UNITED STATES PATENT AND TRADEMARK OFFICE

| APPLICATION NO. | FILING DATE | FIRST NAMED INVENTOR | ATTORNEY DOCKET NO. | CONFIRMATION NO. |
|-----------------|-------------|----------------------|---------------------|------------------|
| 10/553,553 | 08/21/2006 | Stefan Frits Brouwer | 65529-003 | 1858 |

| Office Action Summary | Application No. 10/553,553 | Applicant(s) BROUWER ET AL. | |

DETAILED ACTION

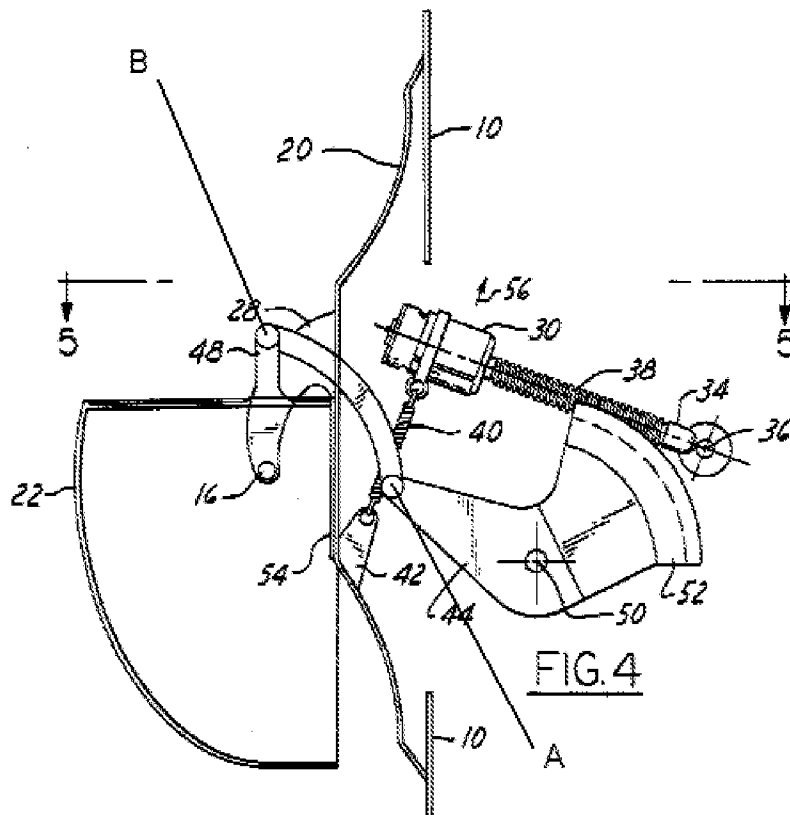
Regarding claim 11, Examiner makes the following findings of fact: Crandall discloses a wing mirror unit (Figs. 3, 4) for a vehicle, comprising: a base plate (20); a supporting frame (22) pivotally connected to the base plate (20) about a main pivot (Examiner Identified element B, see below) and an auxiliary pivot (Examiner identified element A);

and an actuator (30, 38, 52) including an engaging part (38, 52) connected to the supporting frame (22), the actuator connected to the main pivot (B) and configured to move the main pivot (B) in a path further outwardly from said vehicle than the auxiliary pivot (A); wherein the supporting frame (22) is pivotal with respect to the base plate between a folded orientation, in which the supporting frame substantially abuts along a body (Fig. 4) of said vehicle, and an unfolded orientation (Figs. 3 and 4), in which the supporting frame is substantially oriented transversely to the body of said vehicle (Figs. 3 and 4); and further wherein the engaging part (38, 52) is adjustable between a first orientation located near the body of said vehicle and a second orientation located farther outward with respect the body of said vehicle (Figs. 3 and 4). Crandall does not teach that the main pivot moves in a linear path. Crandall and McKee are related as side-view mirrors. McKee teaches linear translation of a pivot joint (Fig. 6). The benefit of this arrangement is the accommodation a shorter motor shaft.
